CHANGE ORDER NUMBER: 3

Project:	<u>1807-252</u>
Roadway:	<u>San Gabriel Ranch Road</u>
CSJ Number:

**San Gabriel Ranch Road Bridge
Williamson County Project No. 1807-252**

Change Order No. 3

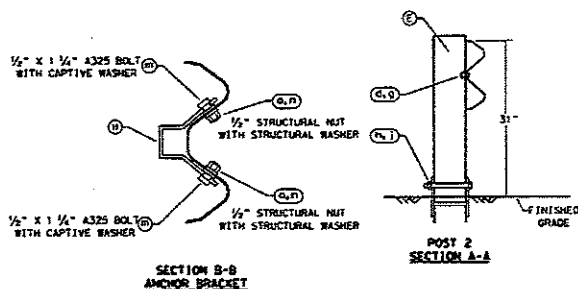
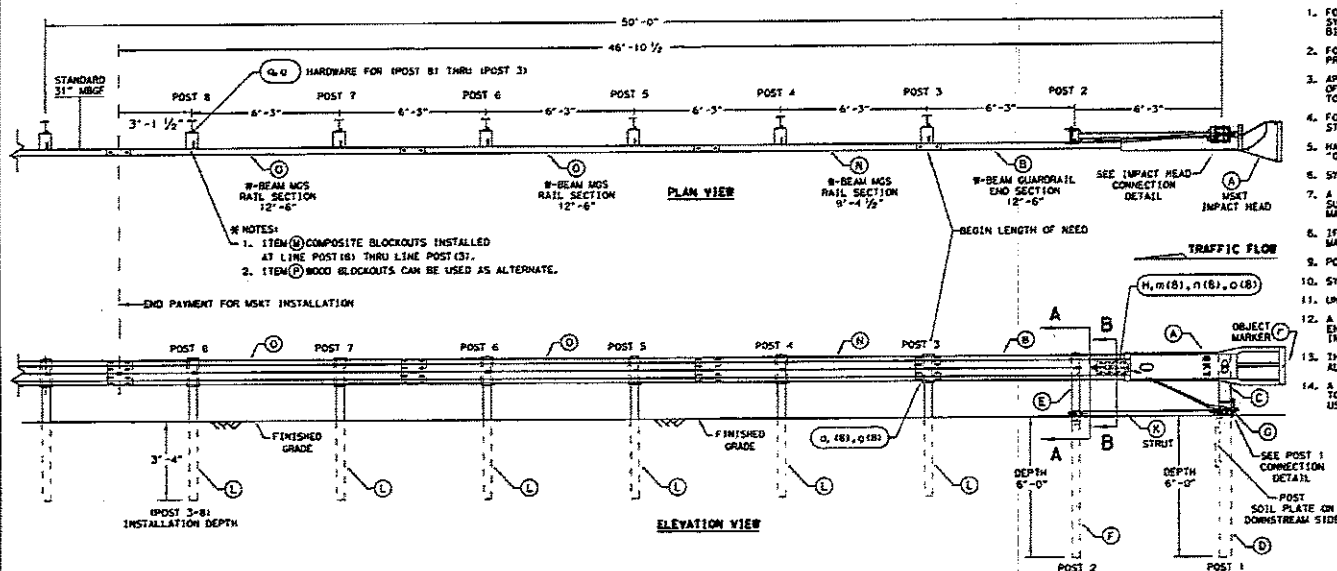
1. Changing the guardrail end treatments from SGT to the MSKT per the 4/28/18 TxDOT memo
2. Adding double service waterline tie-in near station 5+00

Texas Department of Transportation		Design Division Standard	
SINGLE GUARDRAIL TERMINAL			
MSKT-MASH-TL-3			
SGT (12S) 31-18			
FILE: 621263118.dgn	DWG: 12007	CAL: 11	DWG: 11
DATE: 001 APRIL 2018	CONT: 1007	JOB	RIGHTWAY
REVISIONS			
0157	COUNTY	SHEET NO.

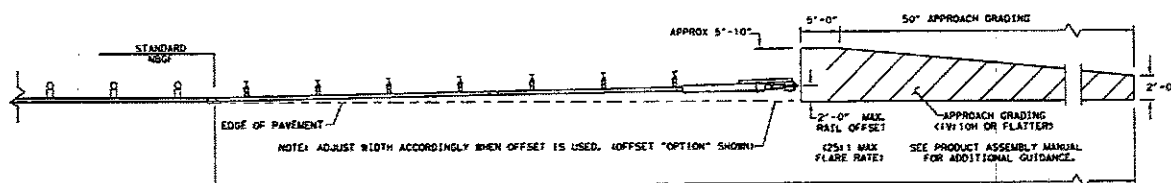
This Change Order also compensates the Contractor for the additional material cost to upgrade guardrail end treatment to TxDOT 2018 standard for crash worthiness per the attached TxDOT memo.

SGT(12S)31-18 The MSKT end terminal is a new standard sheet which depicts a steel post MBGF end terminal system which can be attached to wood or steel post MBGF systems. The system is a re-directive, gating, end terminal system that is proprietary. The system is extruding; meaning the rail panels extrude or spool outwards on the field side upon impact.

WATER LINE RELOCATION PLAN 2

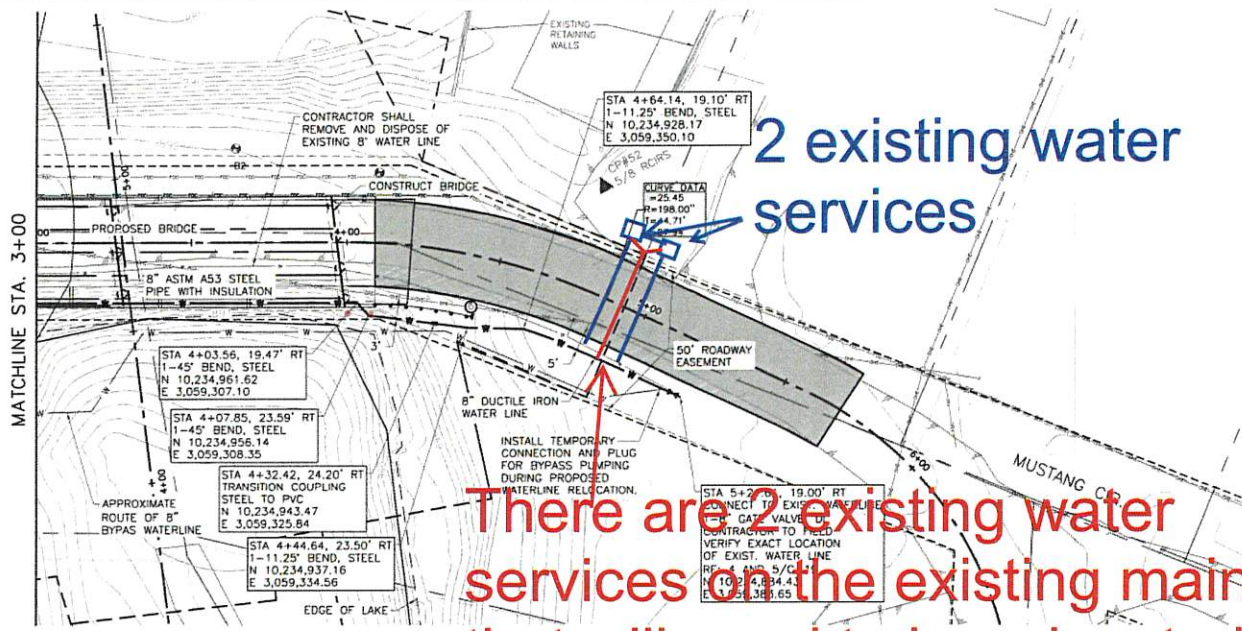
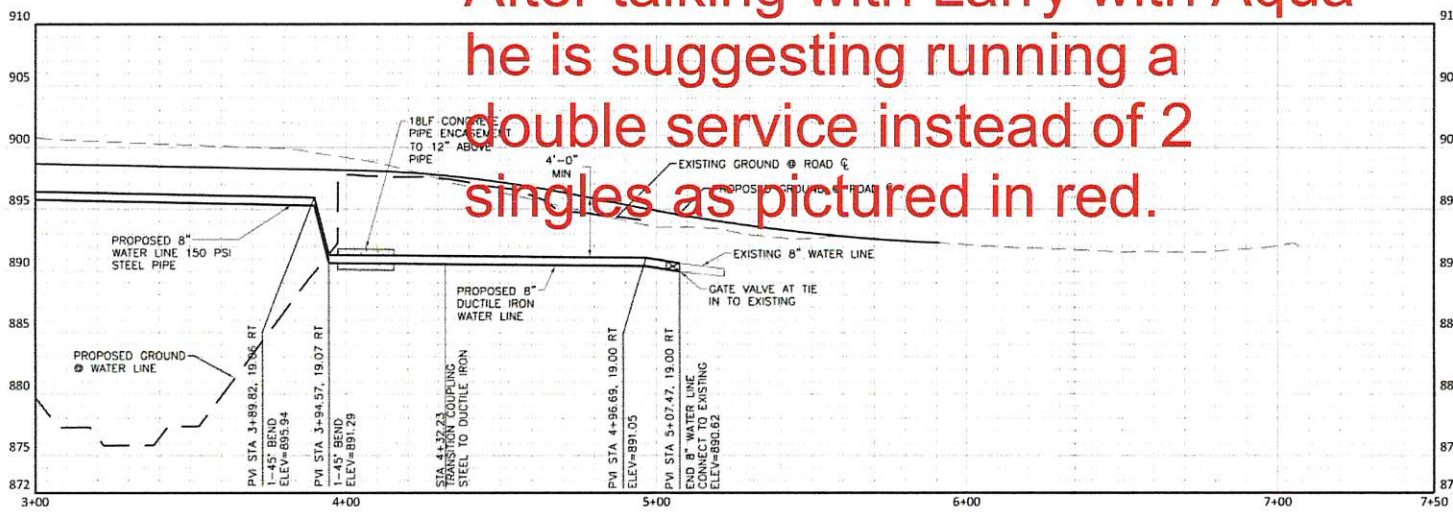
Add double service to serve customers that were not known to be on the existing line.

There are 2 existing water services on the existing main that will need to be relocated. After talking with Larry with Aqua he is suggesting running a double service instead of 2 singles as pictured in red.

This Change Order adds a double service to the new water line and upgrades the guardrail end treatment to the most current TxDOT standard. Two water services were discovered on the existing water line during water line construction that were not called out in the plan. In field discussion, Aqua inspector requested adding a double service to the new water line to replace the two existing services.
